**TRI-PARTY AGREEMENT**

Change Notice Number TPA-CN- 656	TPA CHANGE NOTICE FORM	Date: 3/31/2015
Document Number, Title, and Revision: SGW-56993, Sampling Instruction for the 300-FF-5 Operable Unit Supplemental Post ROD Field Investigation, Rev 0		Date Document Last Issued: 8/27/2014
Originator: Randy Hermann		Phone: 376-4445

Figure 3. Location of Existing Groundwater Wells 399-1-17A and 399-1-55 and Proposed Boreholes

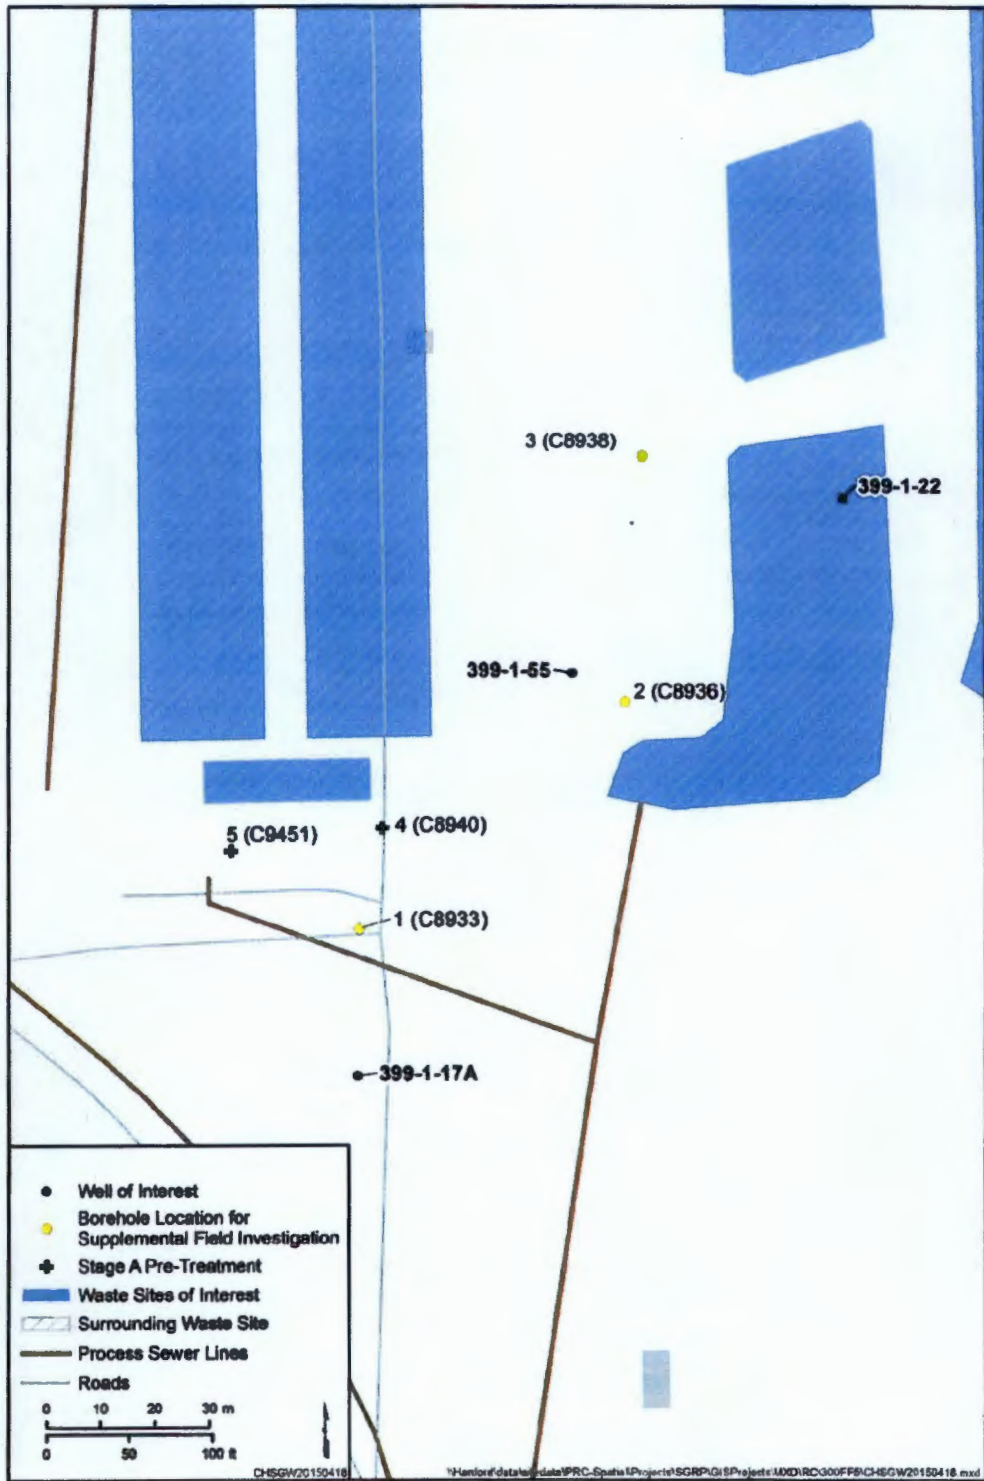
**Description of Change:**  
Document is being updated to include two additional borehole locations that have been selected for pre-treatment sampling. Figure 3 has been updated. Table 3 was updated to include the addition of two new boreholes. Tables 4 and 5 have been updated with the additional borehole identifications.

**Justification and Impacts of Change:**  
 Two wells are needed for additional pre-treatment sampling after the selection of the refined enhanced attenuation area (EAA) as per Principal Study Question 2a. The two additional wells will provide needed information for the characteristics of the vadose zone within the EAA prior to treatment for uranium sequestration using the polyphosphate solution. Figure 3 was updated to reflect the locations of these two wells in relation to the wells of interest referred to in this sampling instruction.

Results from samples collected at the initial three borehole locations was used to further refine the location of the EAA. Two additional boreholes have been selected for pretreatment sampling within the new boundary, and will be used to provide information for PSO 2a, regarding the leachability characteristics of the PRZ and vadose zone. Tests performed on soils from the two new boreholes will be used to document the pre-treatment leachability characteristics of the vadose zone and PRZ within the EAA.

Proposed borehole locations are shown on Figure 3, with the estimated NAD83, *North American Datum of 1983*, coordinates provided in Table 4.
